**Maine Maritime Academy
Castine, Maine**

**Pier Upgrades and Waterfront Improvements Project
March 29, 2024
ADDENDUM NO. 7**

3 DETAIL - RETAINING WALL / SHEET PILE BULKHEAD CLOSURE (BID ALTERNATE 3)
 S-108/S-111 NOT TO SCALE

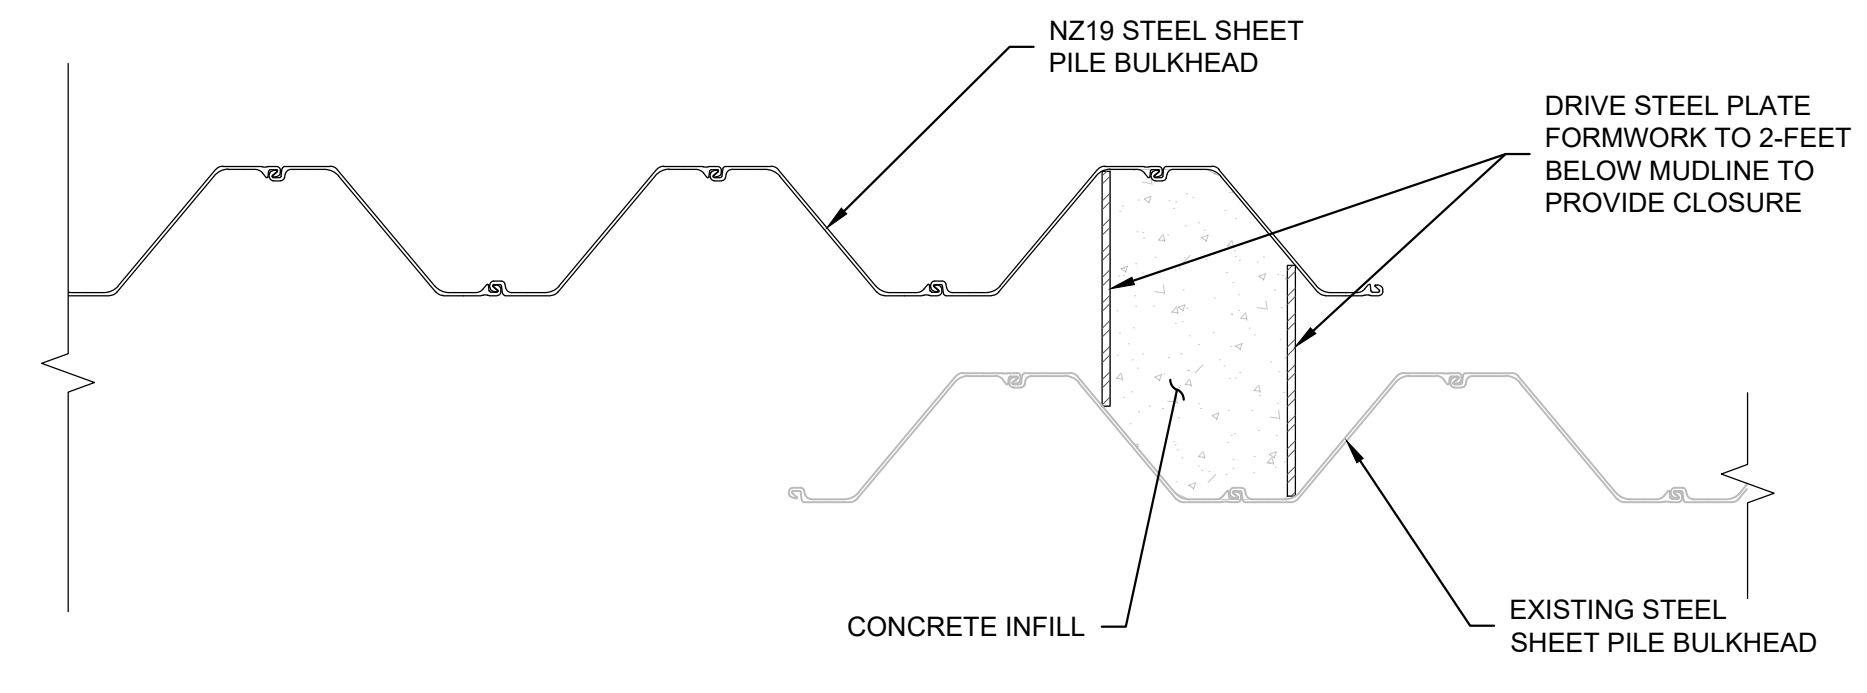
11. IFB Drawing S-111: Detail 3 on sheet S-111 shows a steel plate and vertical sheet pile wall interface. Due to the tapered design of the wall the steel plate may be obstructed by the tail of the retaining wall block. Please advise.

Response 11: Contractor's third-party engineer is responsible for design of the modular block wall and closure to the sheet pile wall.

PROJ MGR: RKC DESIGNED BY: MAR/AFS DATE: JANUARY 2024	REVIEWED BY: CWC DRAWN BY: BDW/MEA PROJECT NO. 03.0035109.00	CHECKED BY: DDF SCALE: REVISION NO.	DRAWING S-114 SHEET NO. 43 OF 142

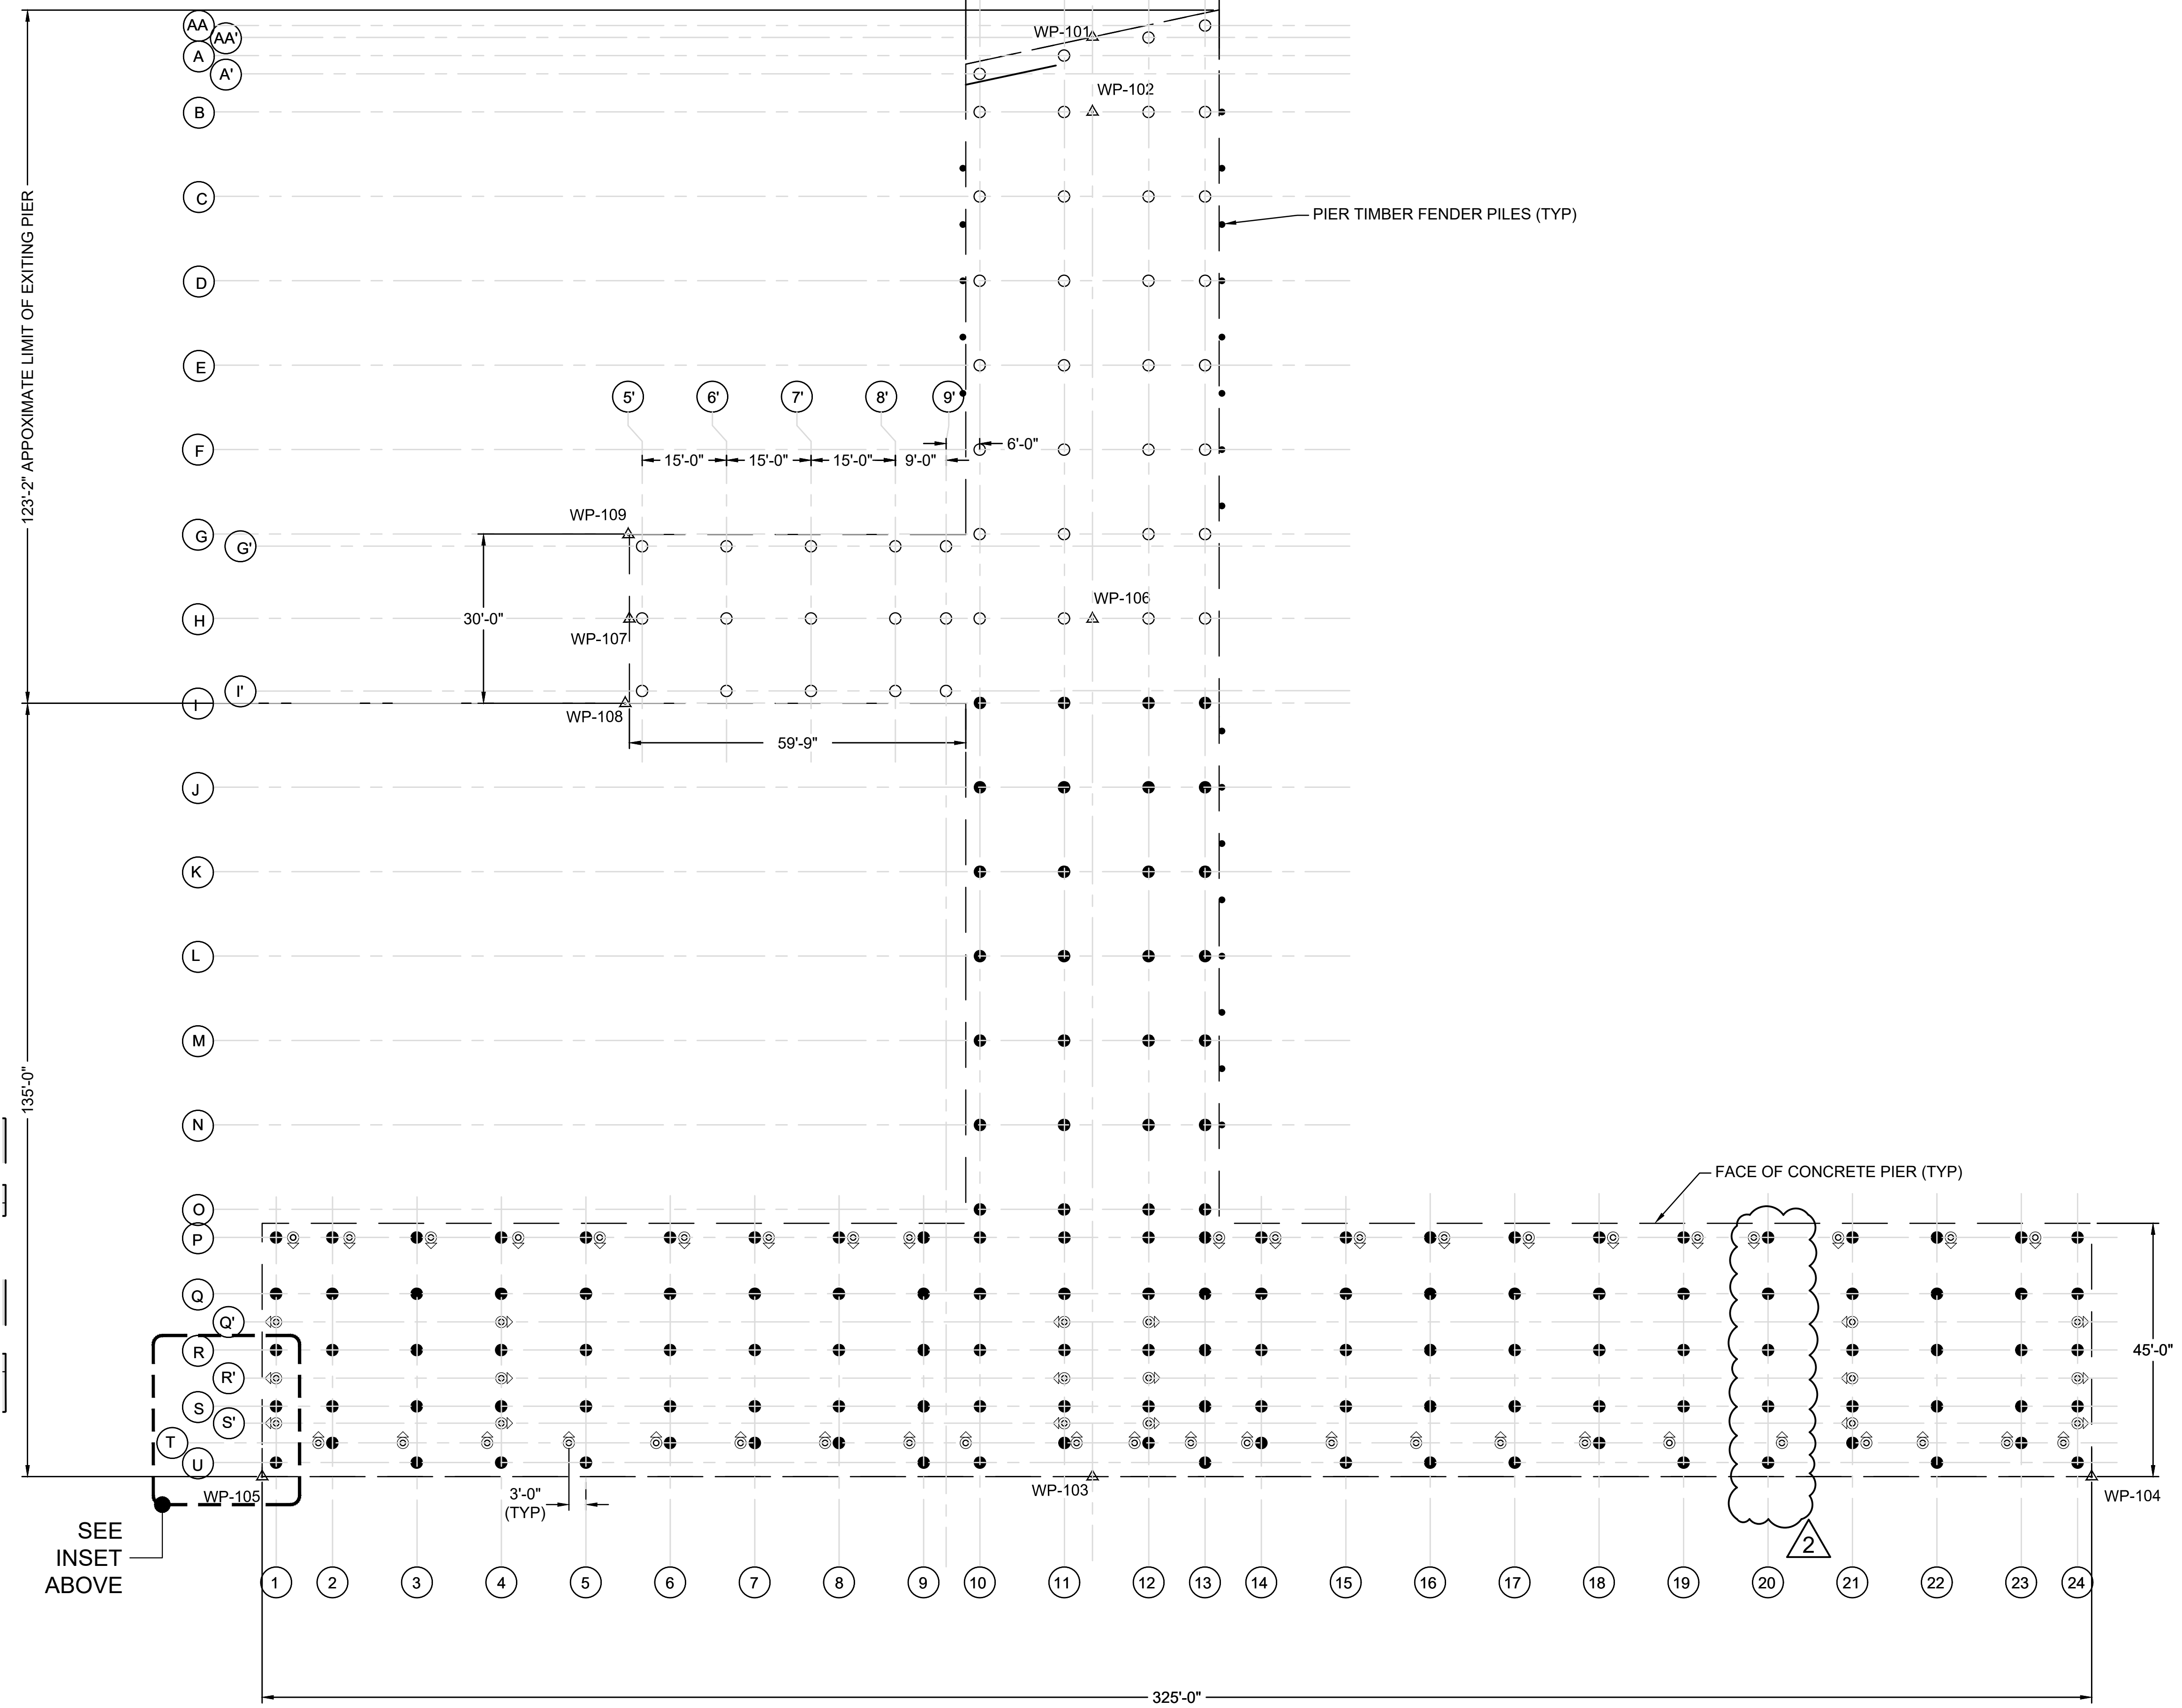
12. IFB Drawing S-114: Note 2 states "See sheet S-123 for Rock Anchor and Rock Socket information." S-123 appears to be a pile cap detail Drawing, S-133 appears to be the Pier Rock Socket & Rock Anchor Drawing. Please confirm.

14. IFB S-114, S-134: The Legend Contained on the Pier Pile Plan shows a symbol for a batter pile with a 20ft Rock Anchor, 5ft Rock socket. The Pier Pile Table on Sheet S-134 indicates none of the pier piles containing rock anchors require Rock Sockets. Please clarify.

19. IFB Drawing S-134: Pile Table S-134 shows all rock anchored pile without a rock socket. Plan View S-114 shows all rock anchored pile with a rock socket.

Question: Please clarify if S-134 table is correct or S-114 is correct for rock sockets in question

Response 12: The note was revised by Addendum 3.
See the attached re-issued IFB Drawing S-114 for additional revisions.

Response 14: See the attached re-issued IFB Drawings S-114 and S-134.

Response 19: See the attached re-issued IFB Drawing S-134.
